City of Portland, Maine – Building or Use Permit Application 389 Congress Street, 04101, Tel: (207) 874-8703, FAX: 874-8716

Location of Construction: 74 Massachusetts Ave		Owner: Singh, Bhupinder & Tejinder		Phone:		Permit No: 980230	
Owner Address: SAA		Lessee/Buyer's Name:		Phone:		BusinessName:	
Contractor Name: Breggia Construction		Address: 46 Congress ST Portland, ME 04101		Phone: 773-7628		<div style="border: 2px solid black; padding: 5px; text-align: center;"> PERMIT ISSUED Permit Issued: MAR 18 1998 CITY OF PORTLAND </div>	
Past Use: I-fan		Proposed Use: Same		COST OF WORK: \$ 31,000.00 PERMIT FEE: \$ 175.00			
Proposed Project Description: Construct Addition RESIDENTIAL 382 Sq Ft				FIRE DEPT. <input type="checkbox"/> Approved <input type="checkbox"/> Denied INSPECTION: Use Group <i>B3</i> Type: <i>5</i> <i>DOC 0-96</i>		Zone: CBL: 186-D-038-117 Zoning Approval: <i>Shaliteman I.D.U.</i> Special Zone or Reviews: <input type="checkbox"/> Shoreland <input type="checkbox"/> Wetland <input type="checkbox"/> Flood Zone <input type="checkbox"/> Subdivision <input type="checkbox"/> Site Plan maj <input type="checkbox"/> minor <input type="checkbox"/> mm <input type="checkbox"/>

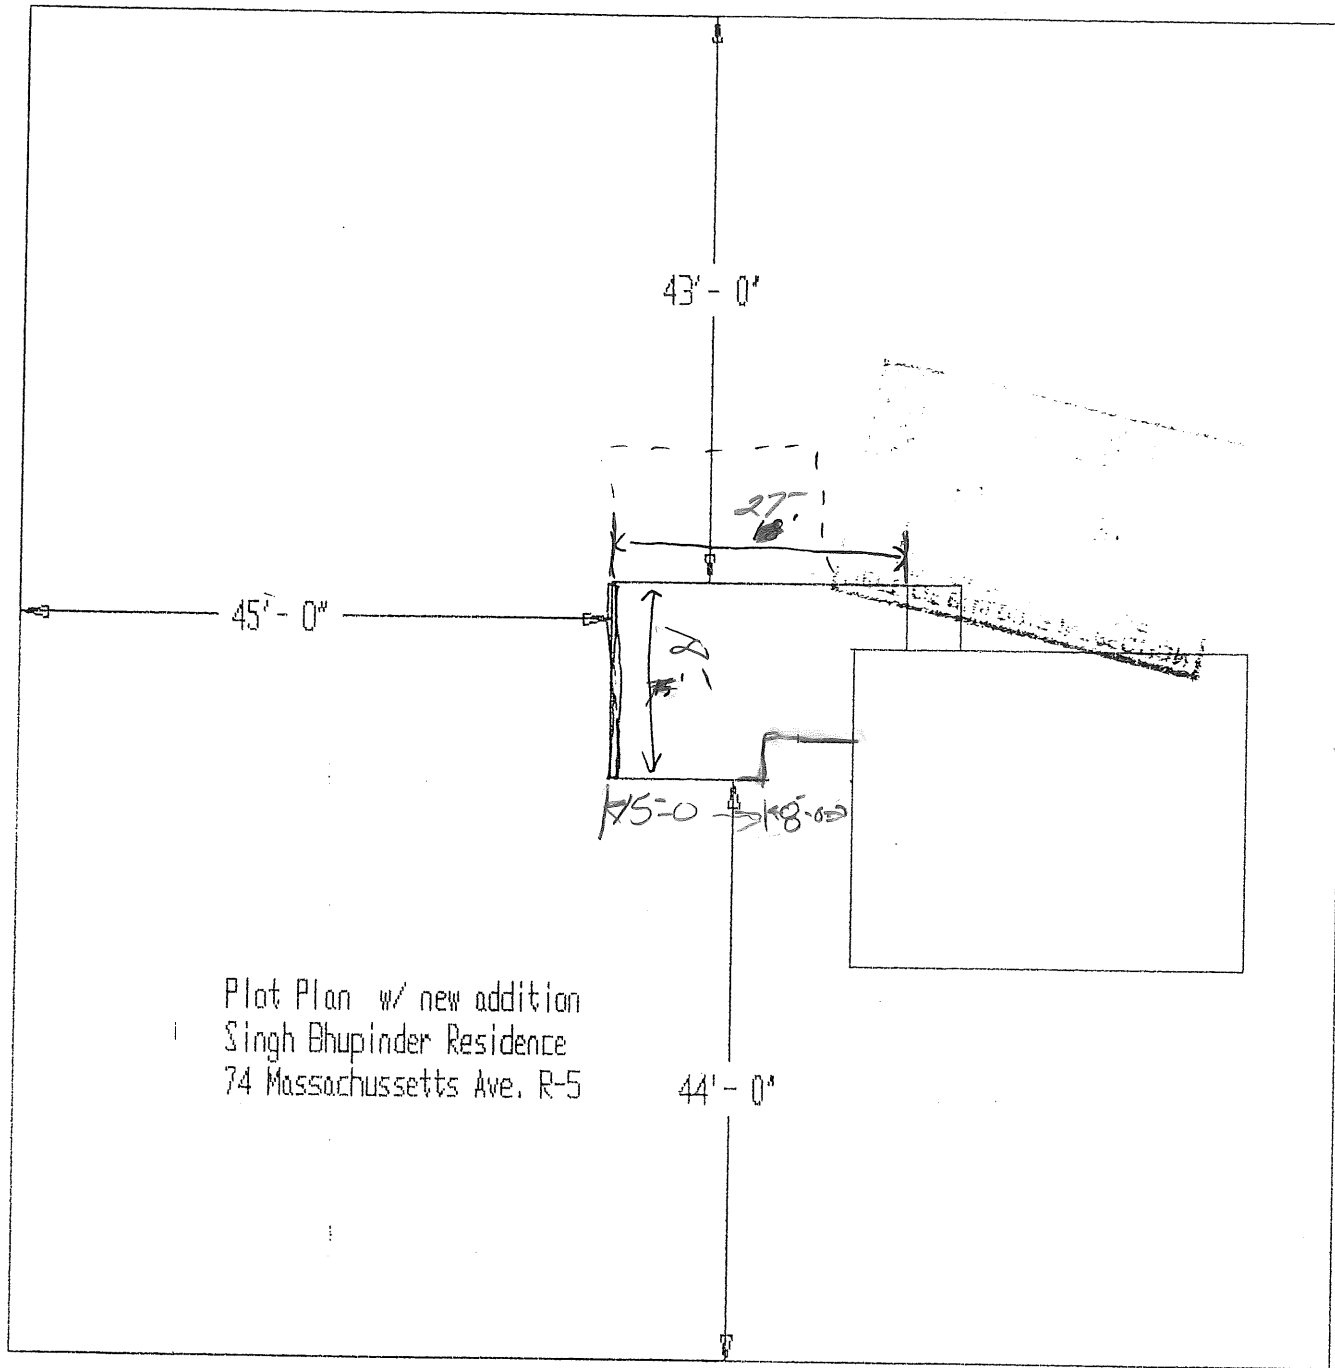
R-5
 20' rear req - shown
 8' side req - shown
 4' to 43'
